Technical Bulletin

TB No. AA-15074

SUBJECT: 429 HUMS Upgrade

PARTS AFFECTED: **Aeronautical Accessories Health and Usage Monitoring System (HUMS) Kit**
P/N 429-260-001

FIGURE 1 – TAIL ROTOR GEARCASE ACCEL RELOCATION (S/N'S 57194-SUB ONLY)

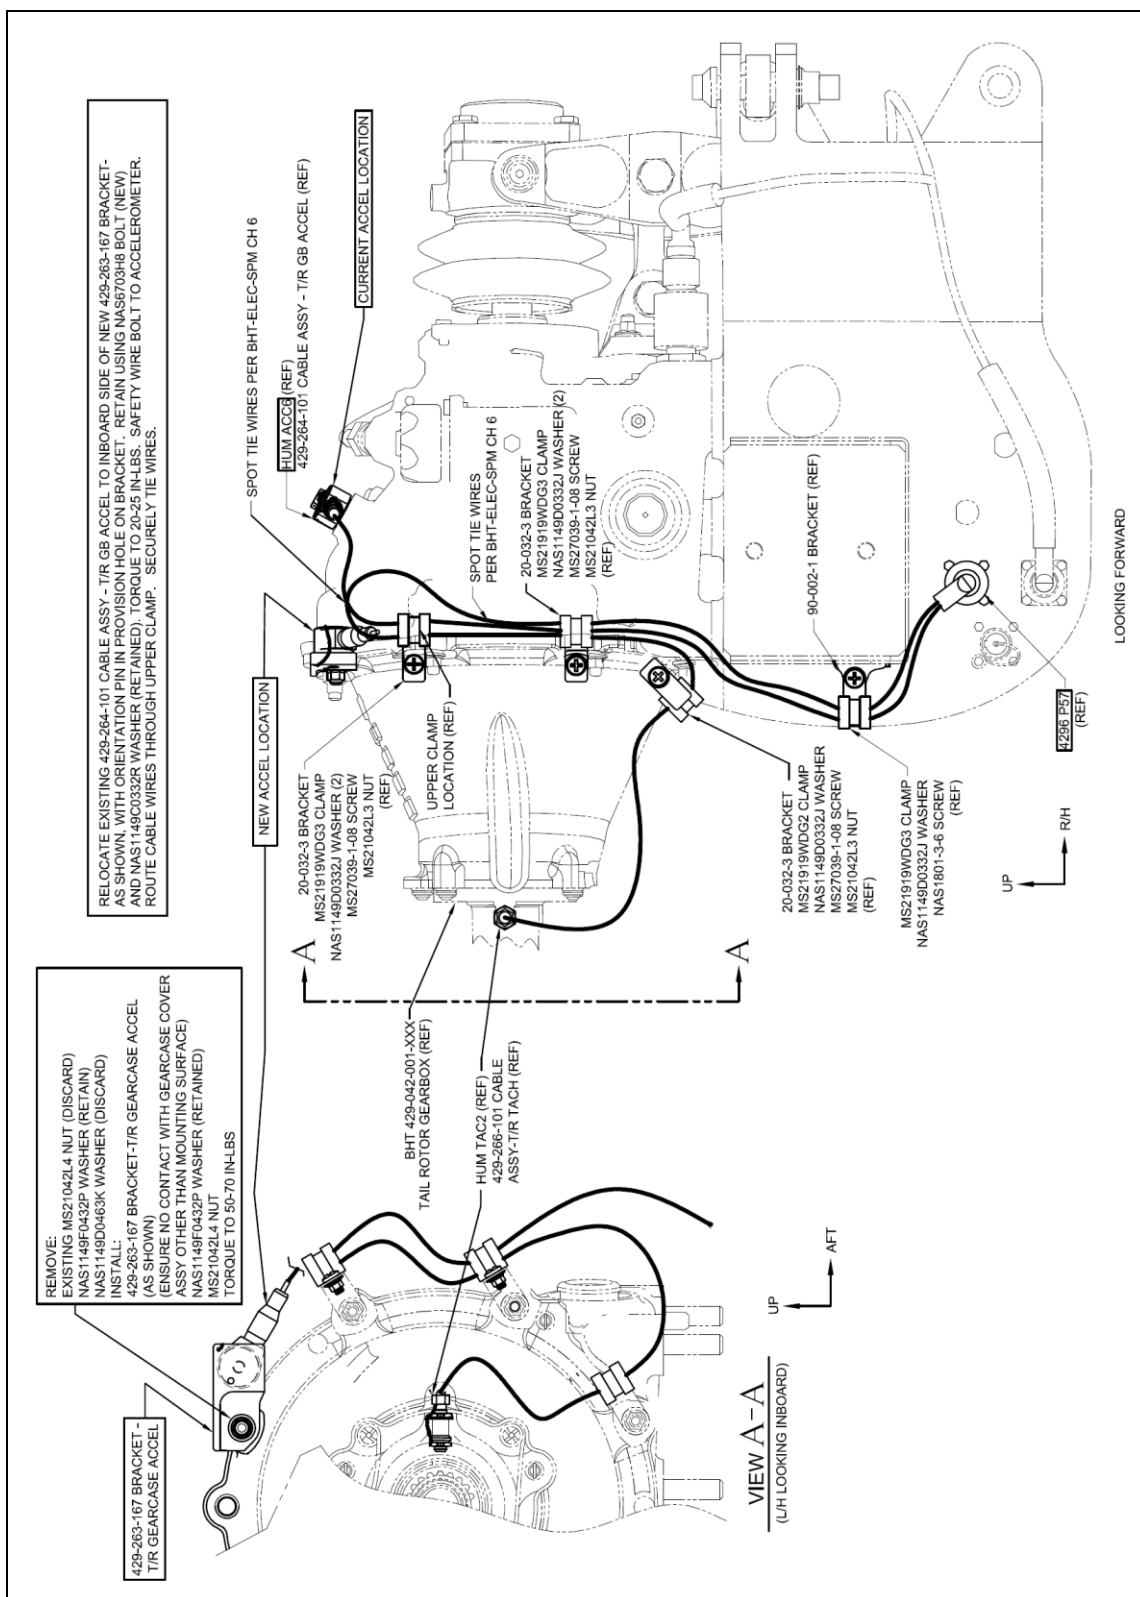
- A. Relocation of Tail Rotor Gearcase accelerometer -
to improve tail rotor balancing
- B. Upgrade PC-GBS 5.5 SP4 Database to V39

1. On existing T/R Gearcase Assembly (BHT 429-042-001-XXX), at the outboard cover side, locate the retaining fastener at the 1 o'clock location, as shown in Figure 1.
2. At this location, remove the existing Nut (MS21042L4) (discard), Washer (NAS1149F0432P) (retain), and Washer (NAS1149D0463K) (discard), shown in Figure 1.
3. Clean the exposed mounting surface on the T/R Gearcase Cover, around the remaining mounting stud, being careful not to damage the threads on the stud.
4. Apply MIL-PRF-81733 Sealant to faying surfaces of Bracket-T/R Gearcase Accel (429-263-167) and T/R Gearcase Cover and install Bracket using Washer (NAS1149F0432P) (retained) and Nut (MS21042L4), as shown in Figure 1. Torque Nut to 50-70 in-lbs.

Ensure there is no contact between the Bracket - T/R Gearcase Accel (429-263-167) and the T/R Gearbox Cover, other than the mounting surface.

5. Remove and retain the Clamp (MS21919WDG3), Washer (NAS1149D0332J) - 2X, Screw (MS27039-1-08), and Nut (MS21042L3), from the upper Bracket (20-032-3) location at the rear of the T/R Gearcase Assembly, to free the wires of the 429-264-101 Cable Assy – T/R GB Accel and the 429-266-101 Cable Assy – T/R Tach, as shown in Figure 1.

6. At the top of the T/R Gearbox Assembly (BHT 429-042-001-XXX), locate the T/R Gearcase Accelerometer (HUM ACC6), part of Cable Assy–T/R GB Accel (429-264-101), as shown in Figure 1.

7. Remove Bolt (NAS6703H7) (discard) and Washer (NAS1149C0332R) (retain) to detach T/R Gearcase Accelerometer (HUM ACC6) from the current mounting location.

8. Using MIL-PRF-81733 Sealant, fill the exposed tapped, mounting hole and anti-rotational pin receptacle hole left open on the top of the T/R Gearbox Assembly.

10. Orient T/R Gearcase Accelerometer (HUM ACC6) to the inboard side of previously installed Bracket-T/R Gearcase Accel (429-263-167), aligning anti-rotational pin on T/R Gearcase Accelerometer (HUM ACC6) with anti-rotational pin receptacle hole provision in the Bracket, as shown in Figure 1.

11. Install accelerometer (HUM ACC6) to Bracket using retained Washer (NAS1149C0332R) and Bolt (NAS6703H8), installing fastener wet with Sealant (MIL-PRF-81733) under the bolt head and on shank. Do not apply Sealant to threads.

12. Torque bolt to 20–25 in-lbs.
13. Apply fillet seal, 1/8 inch bead max, around perimeter of accelerometer using Sealant (MIL-PRF-81733).
14. Lockwire Bolt (NAS6703H8) to the accelerometer, as shown in Figure 1, per AC43.13-1, Chapter 7, Section 7.

**FIGURE 2 – FINAL CABLE ROUTING FOR RELOCATED
TAIL ROTOR GEARCASE ACCELEROMETER**

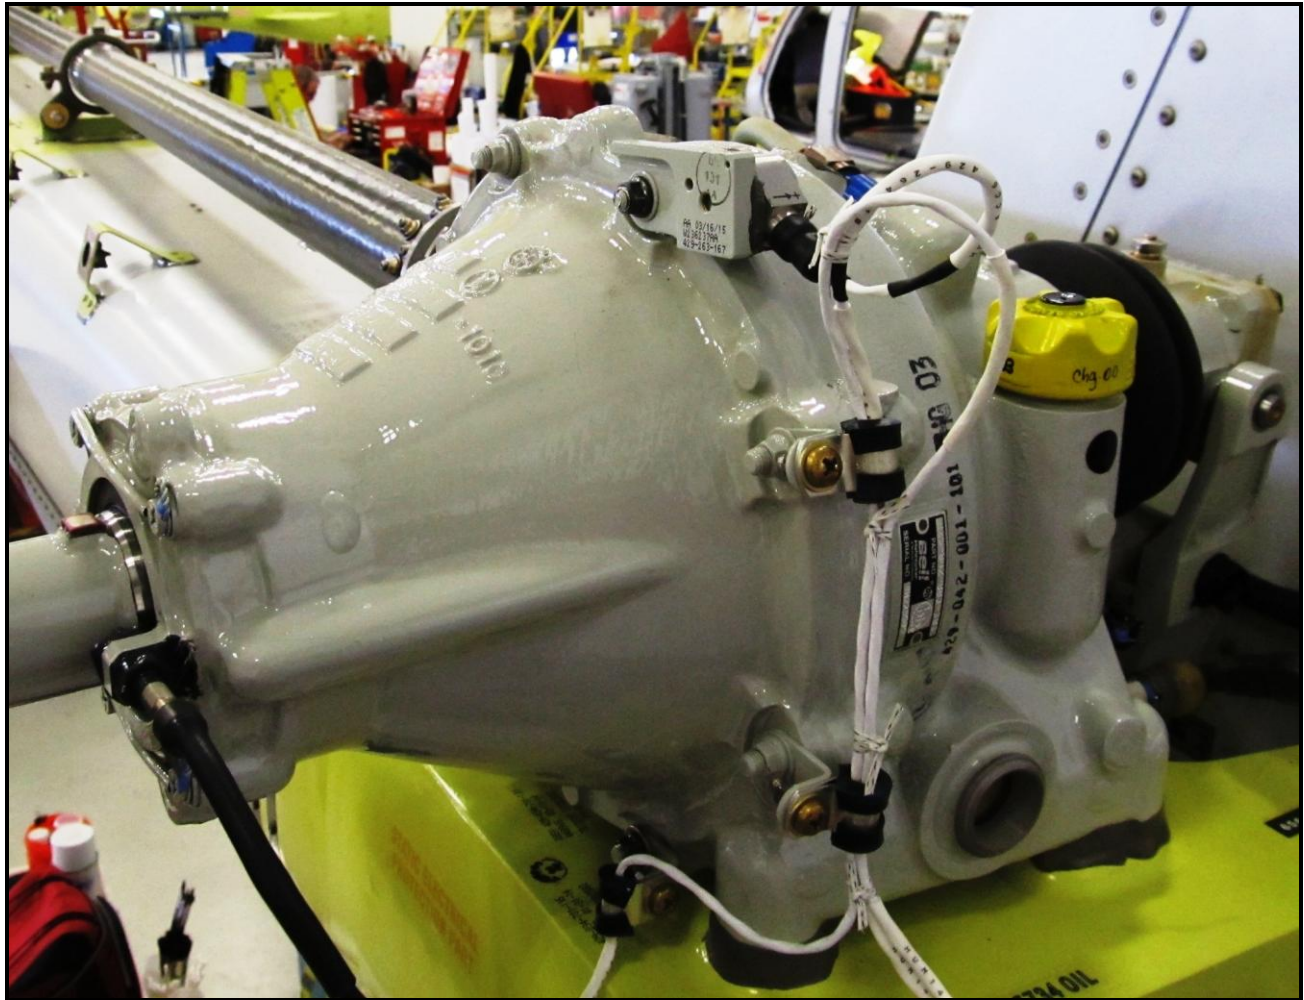
15. Route and loop wires from the 429-264-101 Cable Assy – T/R GB Accel and the 429-266-101 Cable Assy – T/R Tach, as shown Figure 2, re-securing to the upper Bracket (20-032-3) location at the rear of the T/R Gearcase Assembly.

16. Tie wires, where required (ref. Figure 2), to ensure no contact to adjacent parts during operation.
17. Relocation of Tail Rotor Gearcase Accelerometer complete.

FIGURE 3. LABEL, P/N 1209-3196-PF

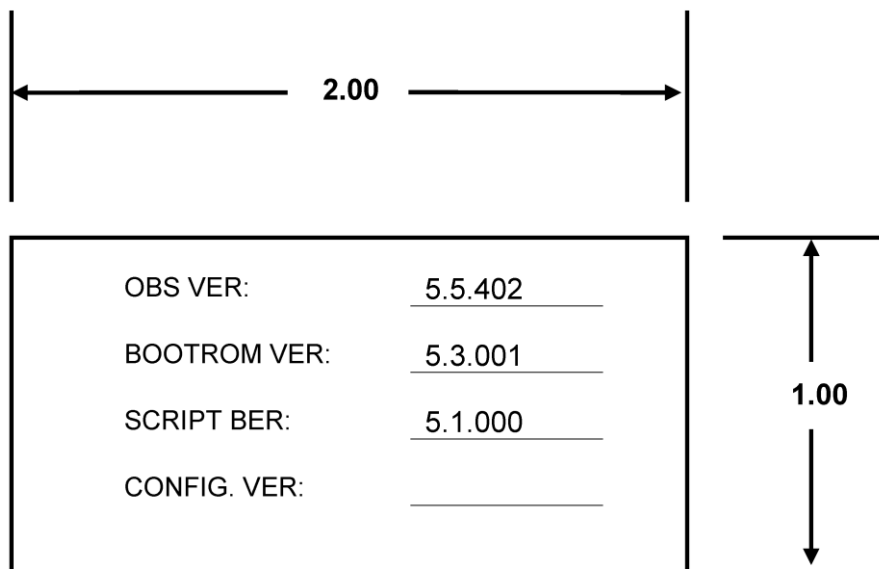
1. Ensure information on Label (1209-3196-PF) and Label (1209-3198-PF), on the MSPU unit, matches with the examples shown in Figure's 3 & 4.
2. Update labels by filling in the required data or by installing new labels, if required, to correspond with your specific aircraft application.
3. PC-GBS 5.5 SP4 Database v39 upgrade complete.

FIGURE 5 – SIGNAL GROUND STUD/WIRE INSTALLATION
(S/N 57001-57080 ONLY – SHOWN) – VIEW LOOKING AFT AT STA 326.0

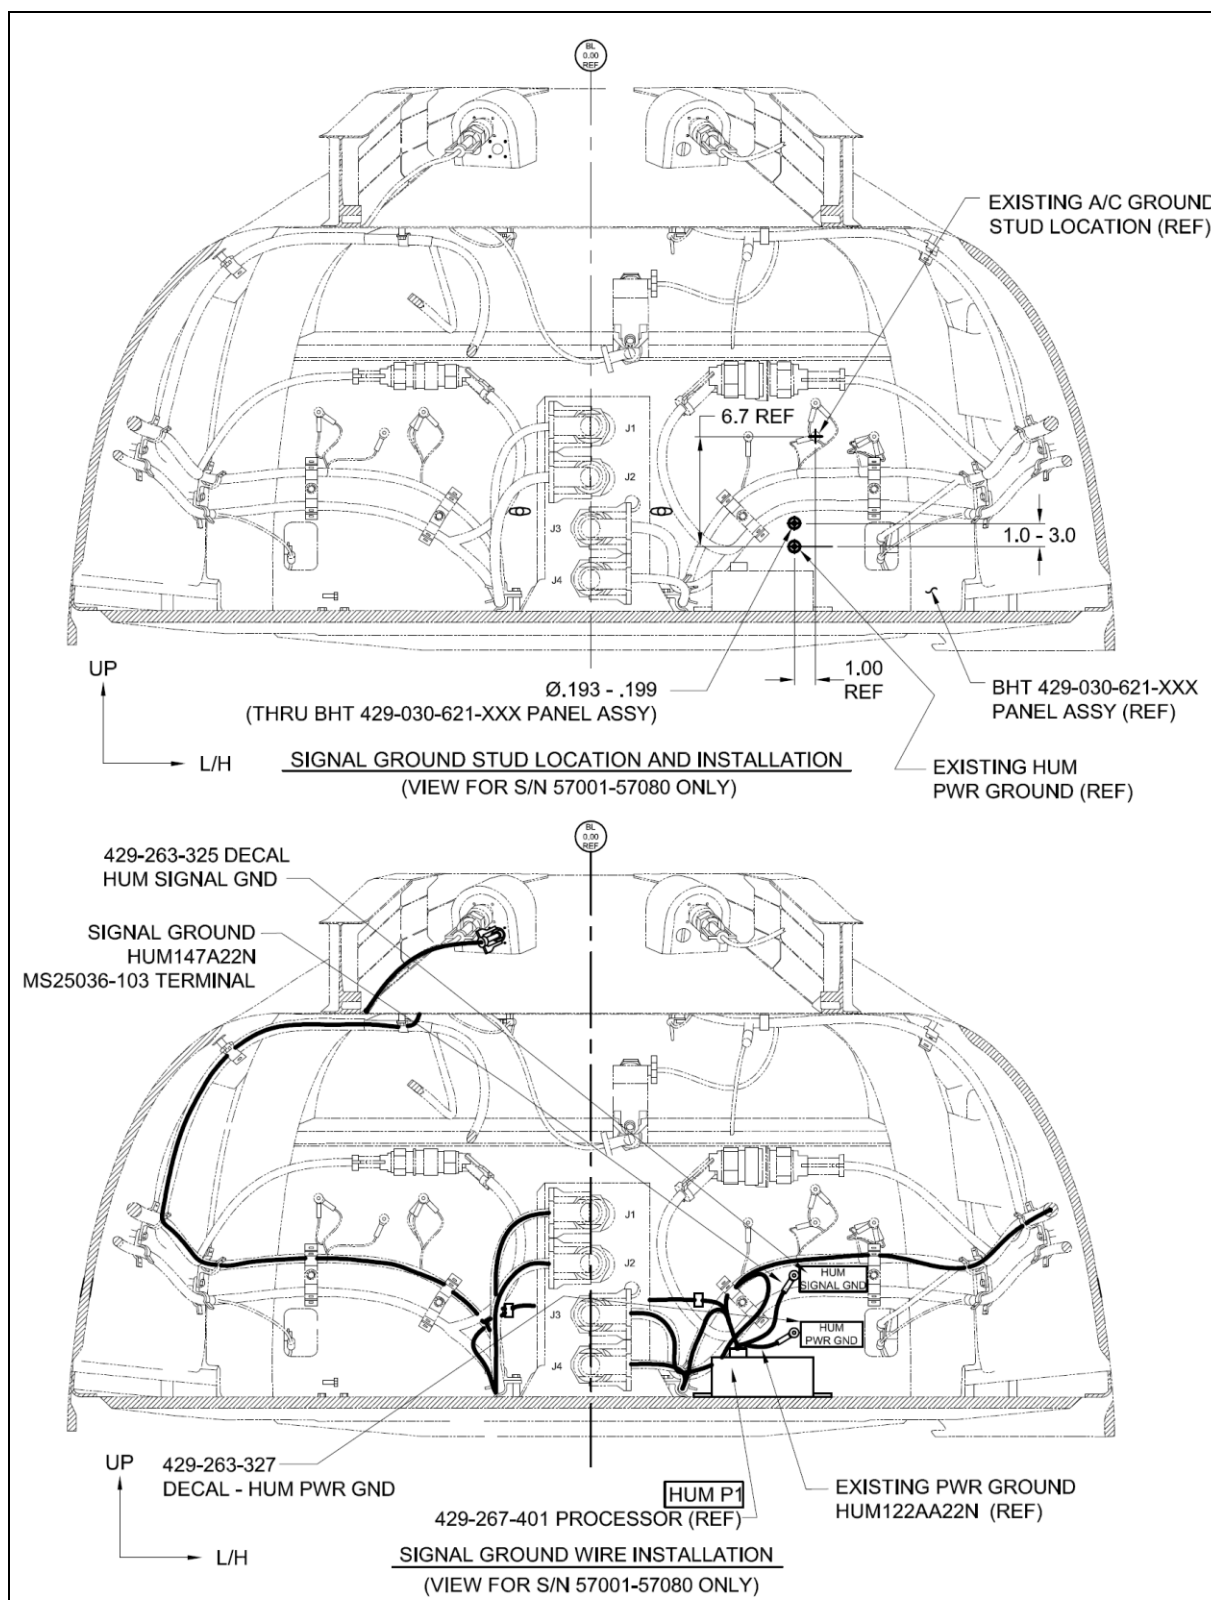
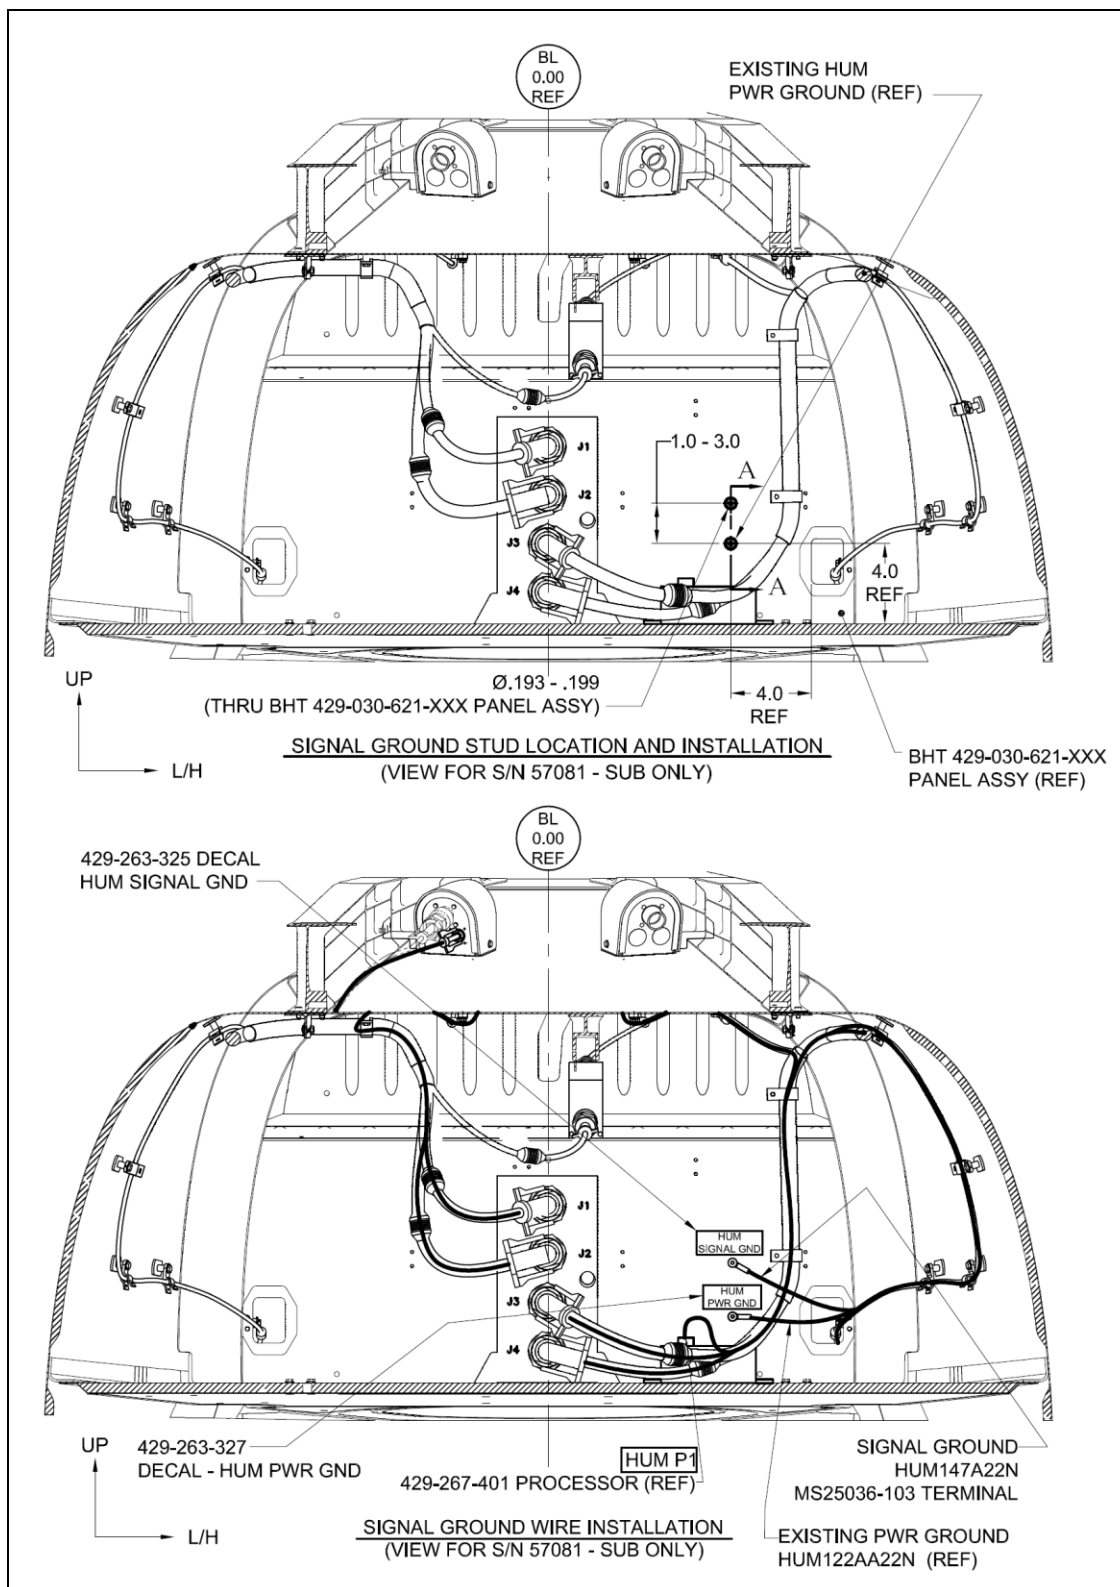
1. Looking aft at STA 326.0, locate Panel Assy (BHT 429-030-621-XXX), as indicated in:
 - a. Figure 5 (for S/N's 57001-57080).
 - b. Figure 6 (for S/N's 57081 – Sub ONLY)

2. Mark location to add the provision for a HUM Signal Ground stud, 1.0"- 3.0" above the existing HUM Power Ground stud, as shown respectively in Figure's 5 & 6.

3. Drill a .193/.199 inch diameter hole through Panel Assy (BHT 429-030-621-XXX) at the marked location.
4. Prepare both sides of the Panel around the drilled hole in accordance with Chapter 8 of the BHT-ELEC-SPM.

6. Ensure proper electrical bond of 2.5 milliohms or less per AC43.13-1, Chapter 11, Section 15.
7. Install HUM147A22N Signal ground wire as shown respectively in Figure's 5 & 6 and per View B-B, in Figure 7 and Figure 8.

8. After installation, label HUM Power Ground stud using 429-263-327 Decal – HUM PWR GND and HUM Signal Ground Stud using 429-263-325 Decal – HUM SIGNAL GND, as shown respectively in Figure's 5 & 6.

**FIGURE 7 – SIGNAL GROUND STUD/WIRE INSTALLATION**

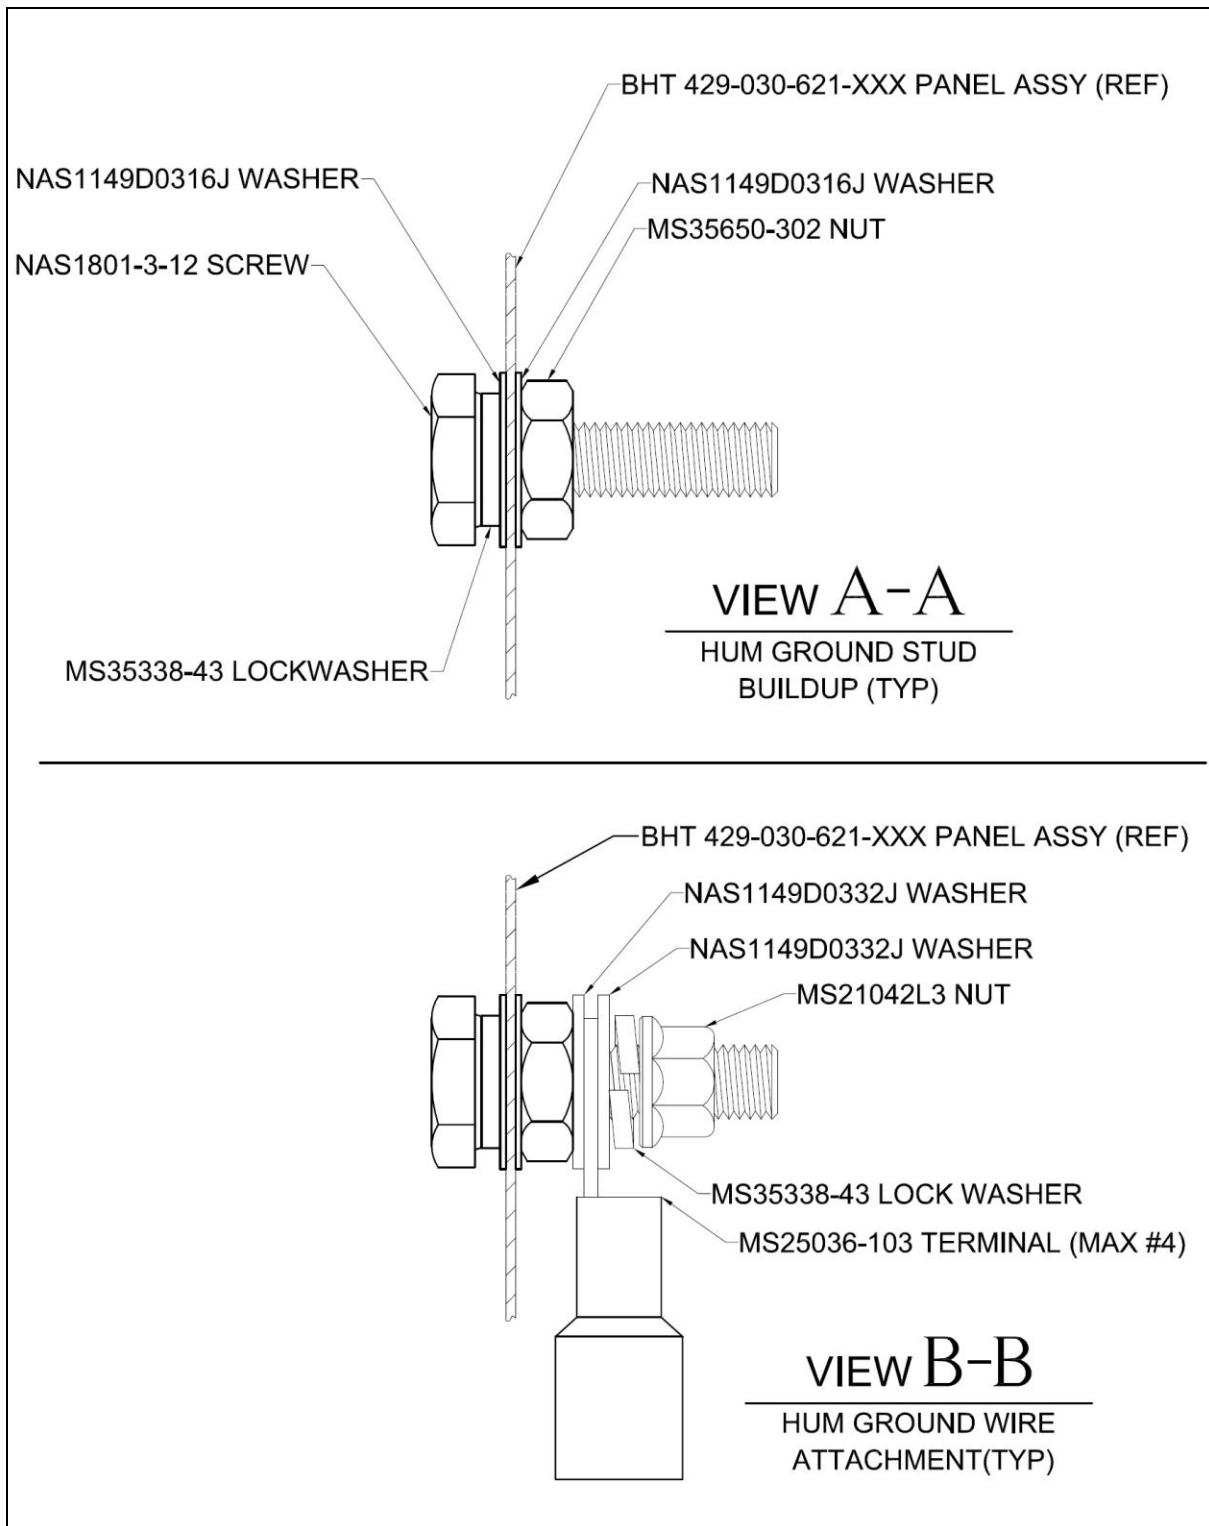
5. Install defined hardware as shown in View A-A, in Figure 7 and seal electrical bond in accordance with Chapter 8 of the BHT-ELEC-SPM using Sealant MIL-PRF-81733.
